Status of Penetrations

15.02.2017

SPFT MODIFICATION:

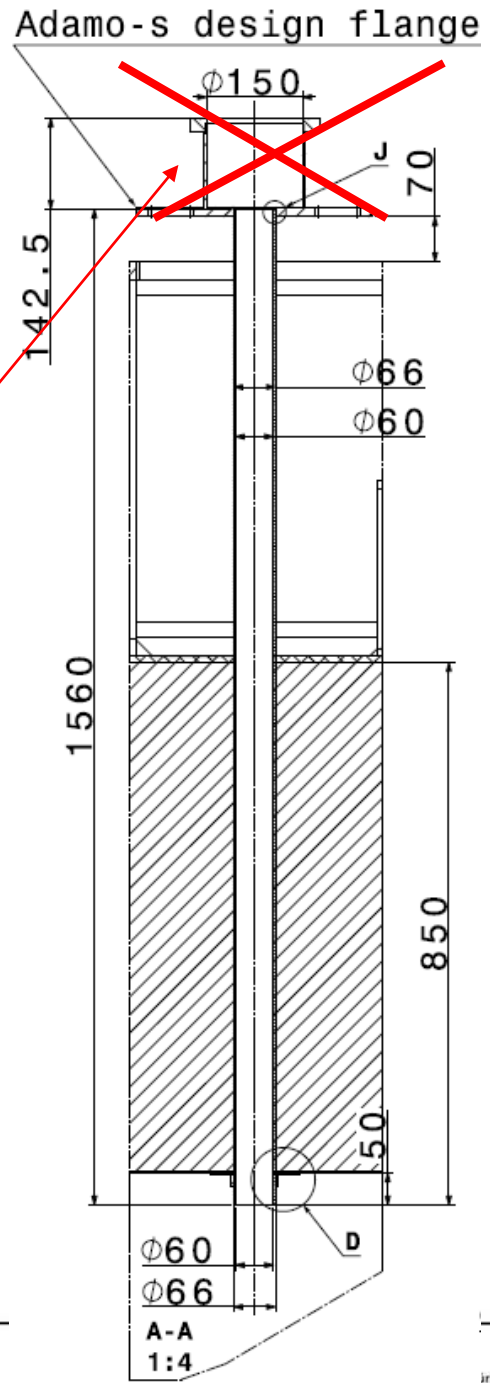
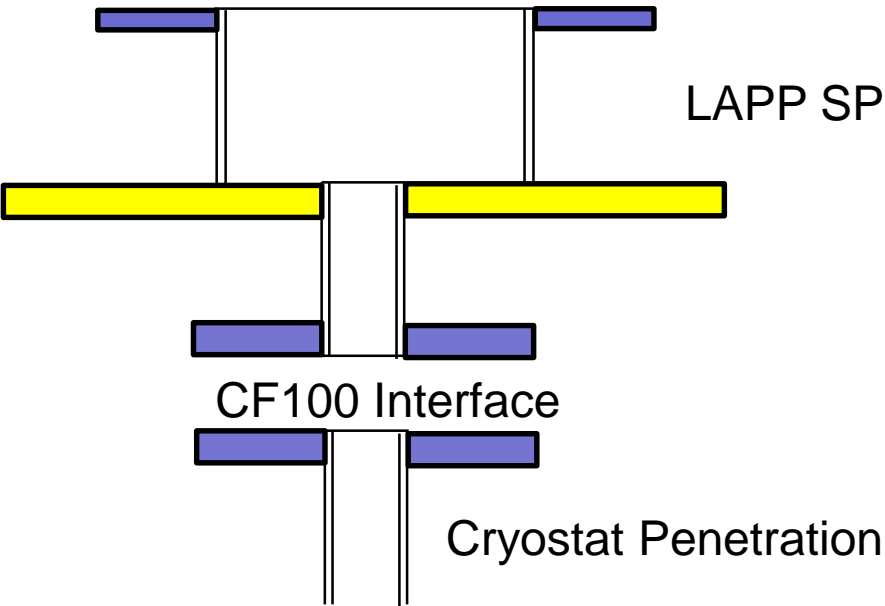
- Instead of Welding directly the «Adamo's design flange» we agreed to Weld a simple CF100 Flange at the pipe
- We will than have an adaptor: CF100 + pipe + «Adamo's design flange»

HVFT CROSSING PIPE:

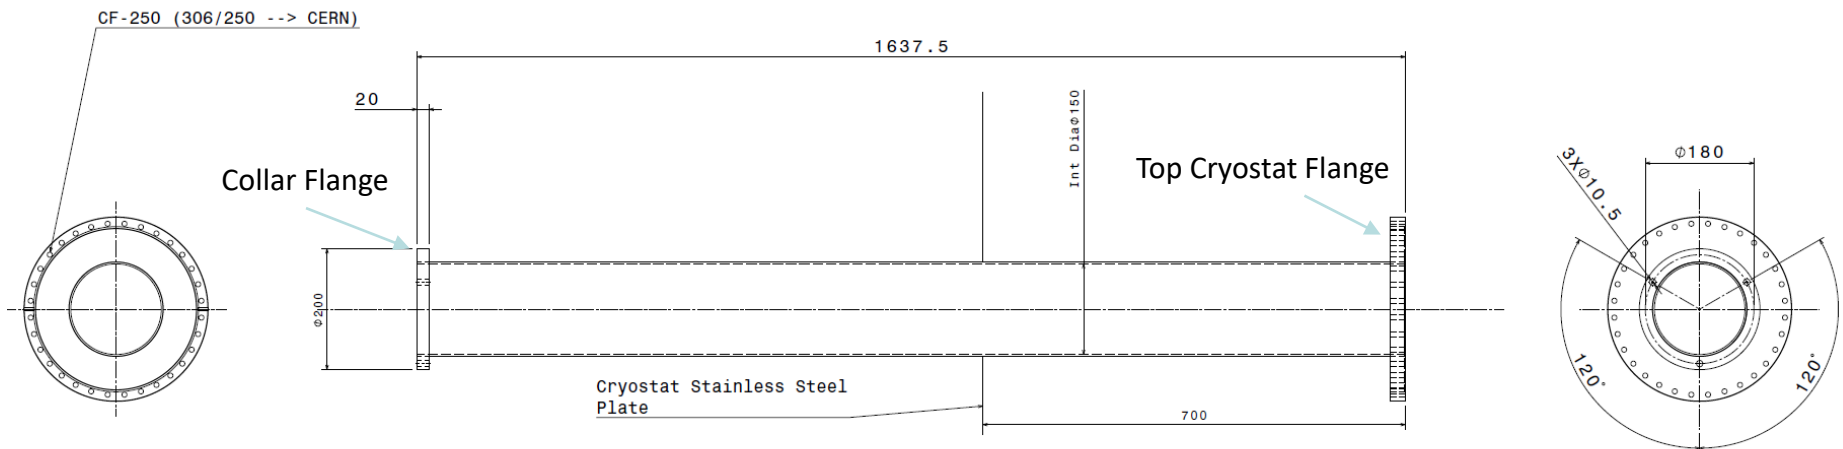
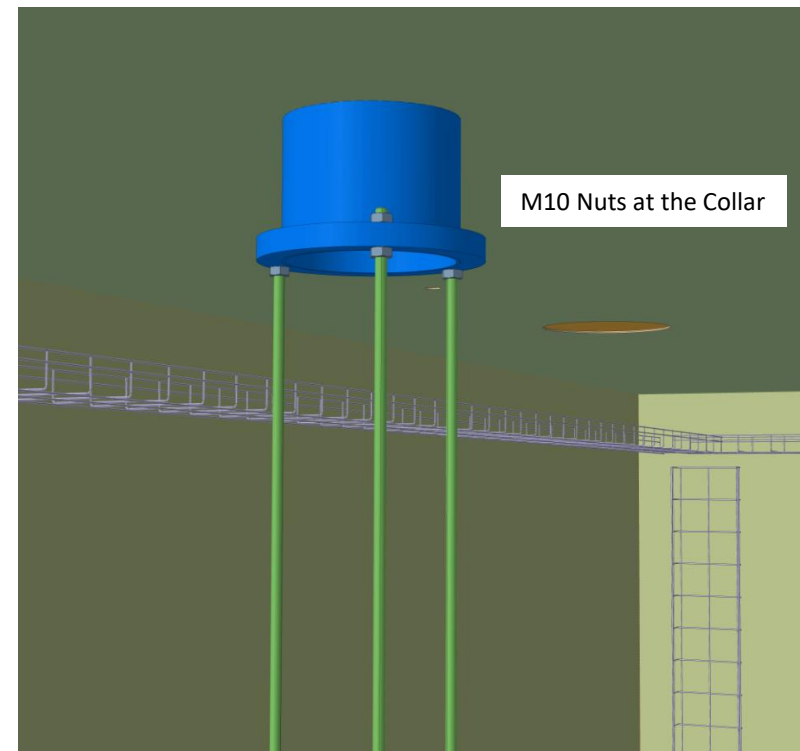
- The Bottom Pipe of the HV Penetration needs a collar in order to connect 3x M10 Threaded Rods for hanging the HVFT degrader
- Collar needs to be wide enough in order that a M10 Nuts can be placed (see picture)

SGFT CROSSING PIPE:

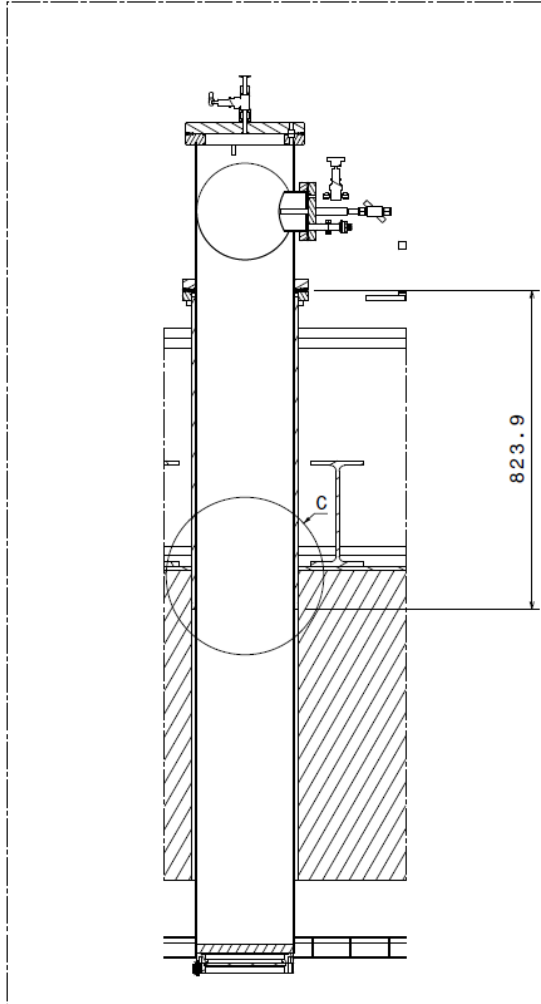
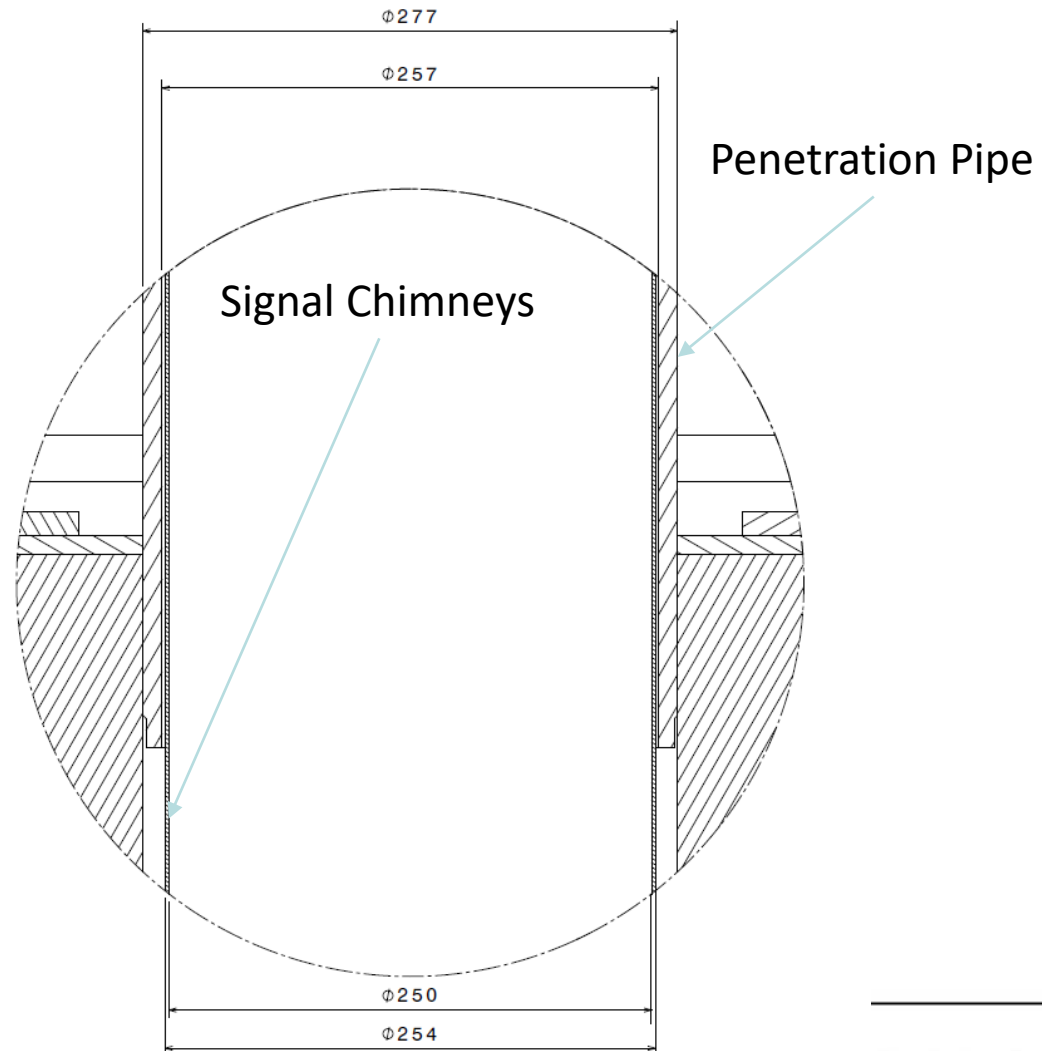
- 1.5mm clearance over 824mm length
- Purge need to be somewhere under the flange
→ type size and length according to Cryogenic Group (M.Chalifour)
